San Luis Rio Colorado Project Final Environmental Impact Statement

DOE/EIS-0395

TITLE: San Luis Rio Colorado Project Final Environmental Impact Statement, DOE/EIS-0395

Response to Comments Received on the Draft EIS; Including Corrections, Modifications, and Supplemental Information to Draft Environmental Impact Statement

Figure 1. Proposed Transmission Line Plan and Profile near Aux II

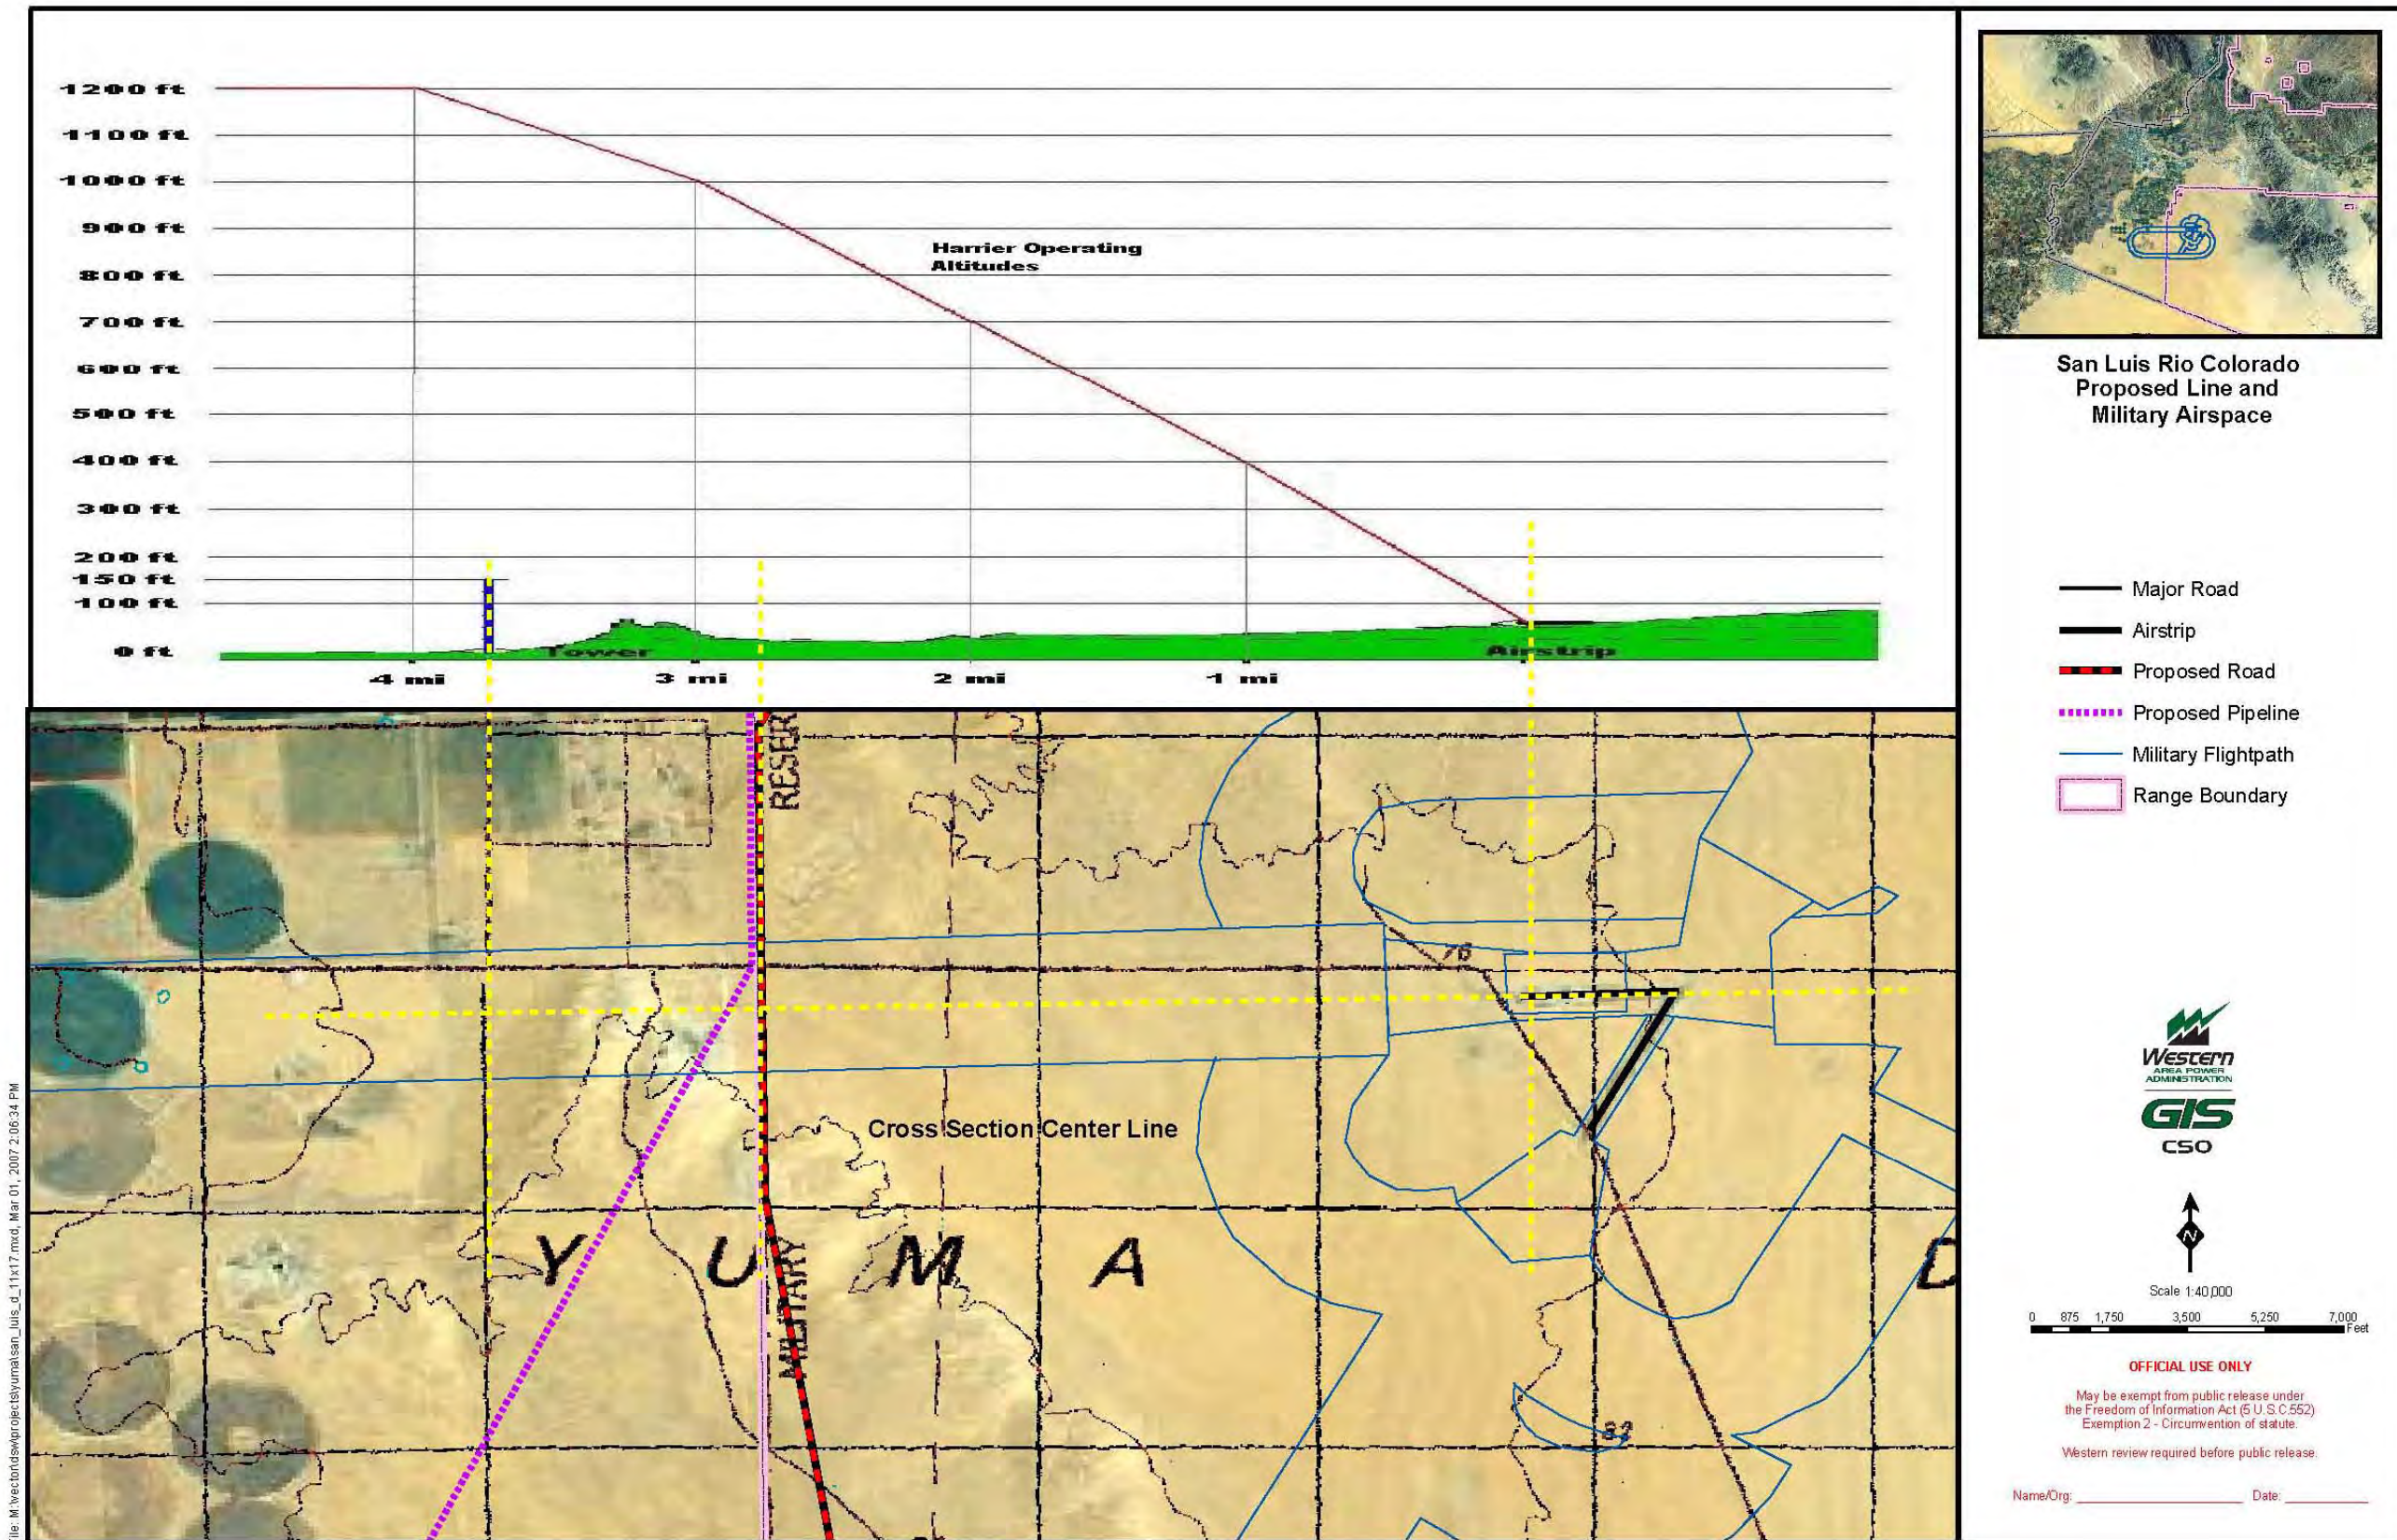
6.5 → The drawings contained in the EIS do not provide adequate detail of your proposed alignment either in relation to your current easement along the western edge of the Barry M. Goldwater Range (BMGR), or in relation to the Area Service Highway (ASH) right-of-way. This is especially critical in the northwest corner of the range. Your proposed corridor appears to be approximately 1/2 mile wide as shown on land2_SLRC_082406.doc, figure 2.1-2, pg 21.

Figure 2. Restricted Airspace

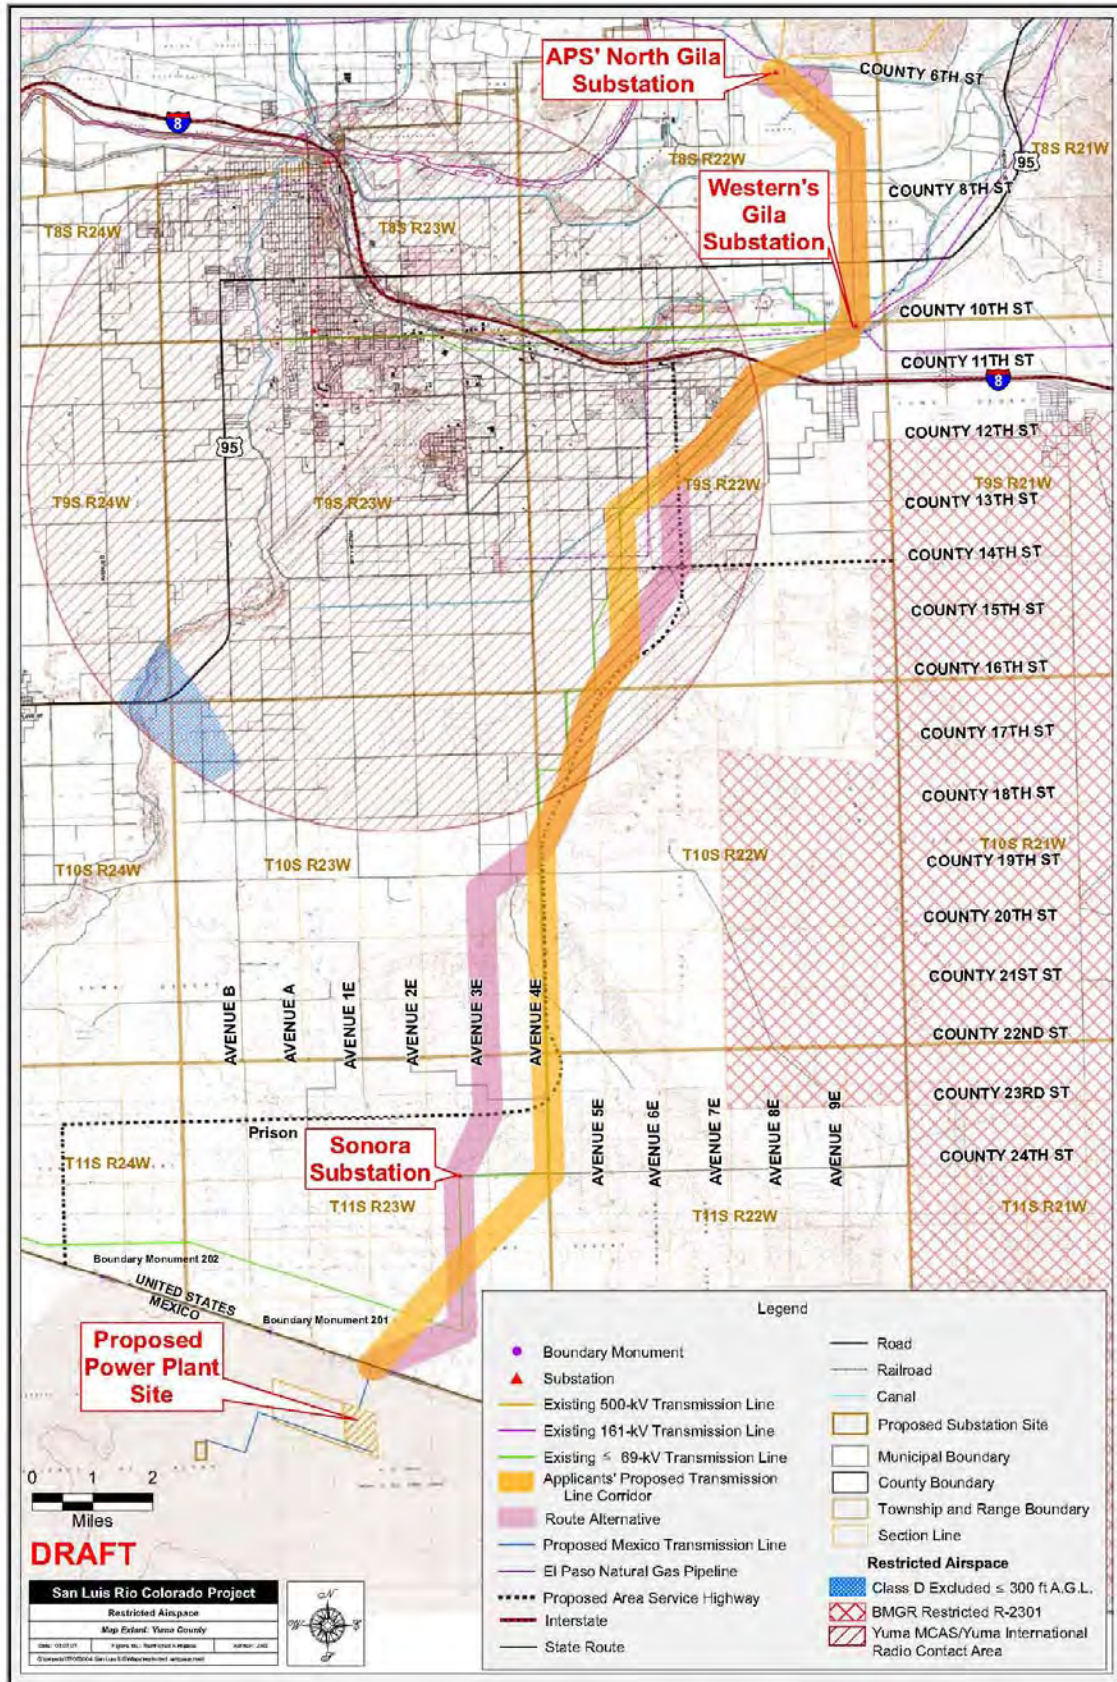
Civilian aircraft, including Light Sport and aerial applicators, use a flight corridor located between the restricted airspace of the BMGR and the Air Traffic Control area of the MCAS Yuma/ Yuma International Airport (see figure 2). The proposed transmission line would be located within 1 mile of the existing Gila-Sonora Transmission Line in the area of this flight corridor. Aircraft flying in this corridor are not required to maintain radio contact with Air Traffic Control when flying below 1,200 feet. Minimum safe altitudes for aviation recommend that a person operating an aircraft maintain an altitude of at least 1,000 feet above the highest obstacle when flying over a built-up area and operate the aircraft not closer than 500 feet to any person, vessel, vehicle, or structure in a sparse area (FAR [Federal Aviation Regulation] part 91). Following these guidelines, persons operating aircraft are recommended to maintain a minimum altitude of 500 feet above structures; therefore, in the area of the proposed transmission line, flying at a minimum height of 650 feet would allow the recommended clearance for aviation safety and still allow the aircraft to remain in an airspace that does not require Air Traffic Control radio contact. The Proposed Project would fully comply with all applicable FAA regulations.

Figure 3. FTHL MA

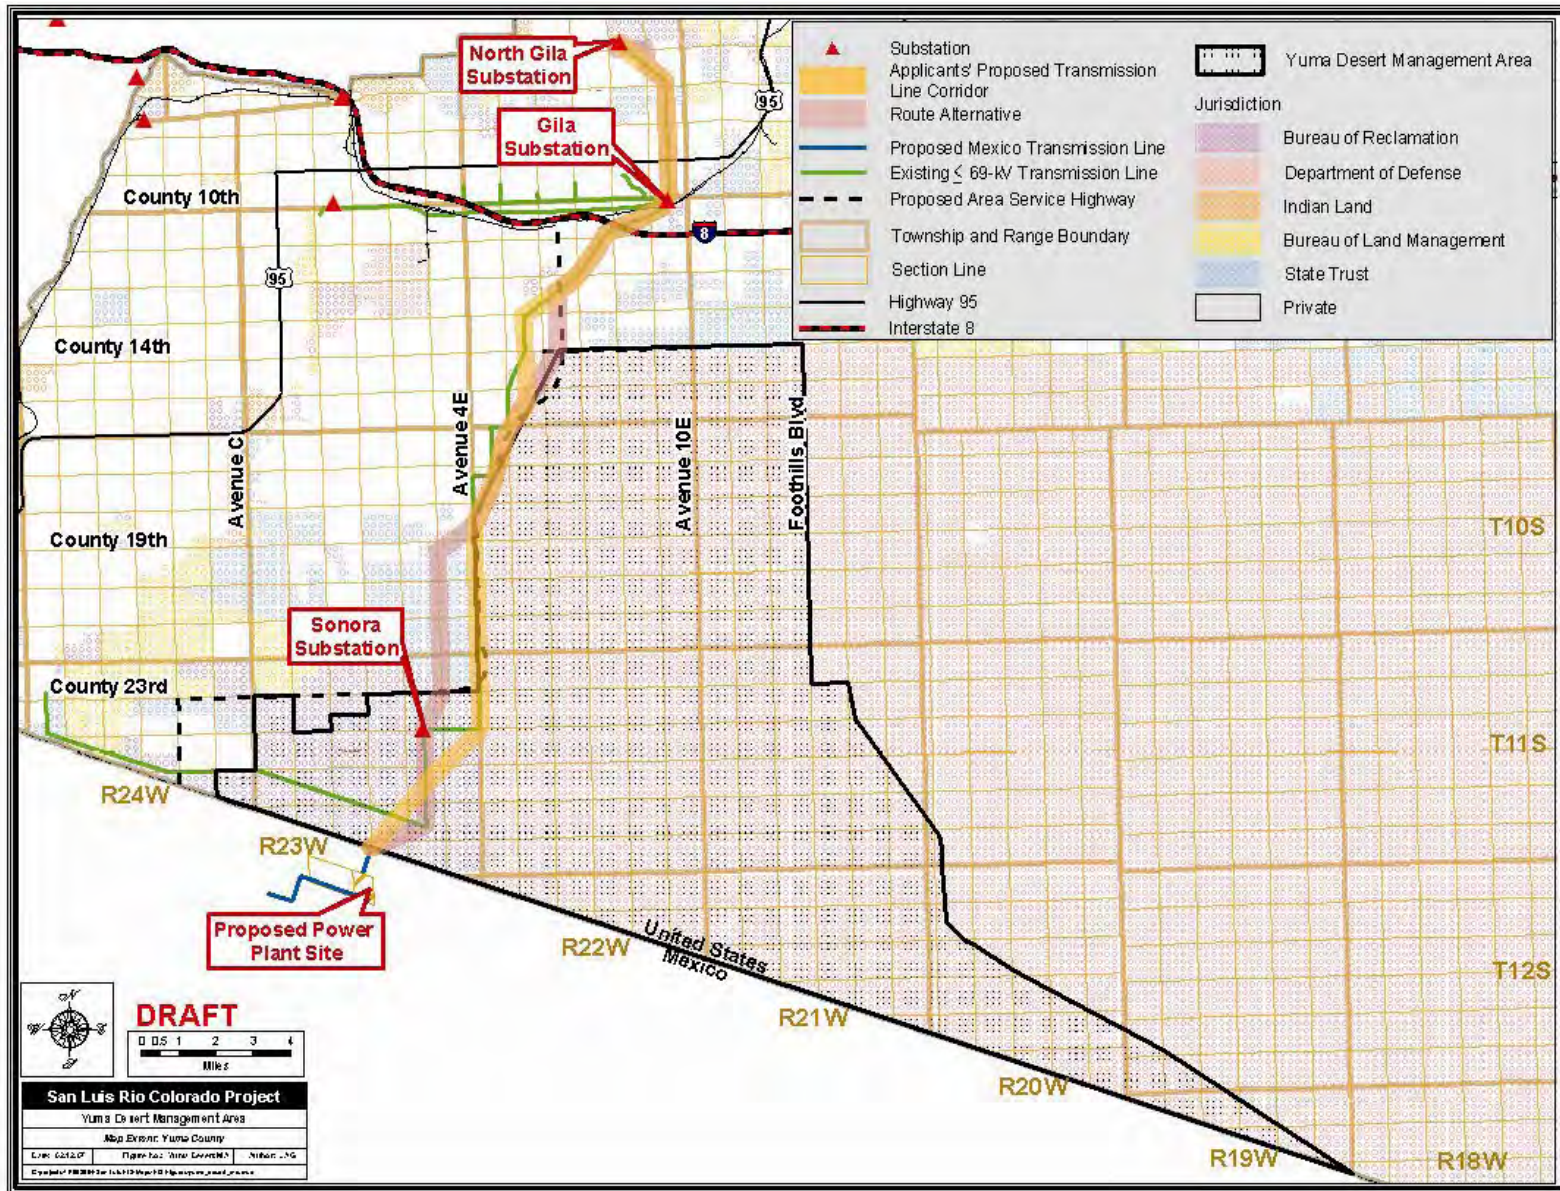
Figure 3 illustrates the location of the FTHL MA, proposed transmission line border-crossing location, Applicants' Proposed Action, and Route Alternative. The San Luis Rio Colorado Project is an independent non-Federal project proposal that was developed by North Branch Resources, LLC (NBR) and Generadora del Desierto, S.A. de C.V. (GDD) (collectively termed the Applicants). As discussed in the Draft EIS, Section 1.2.6, Applicants' Project Objectives, to remain economically viable the Applicants are basing their Proposed Project on the power plant site already owned by GDD. In addition, the Applicants' power plant site is near enough to the border to allow for private ownership and control of the short transmission line section in Mexico. The proposed power plant, proposed power plant location, and proposed transmission line from the plant to the border would be an independent non-Federal action located in Mexico and, therefore, not subject to the National Environmental Policy Act (NEPA). Based on these
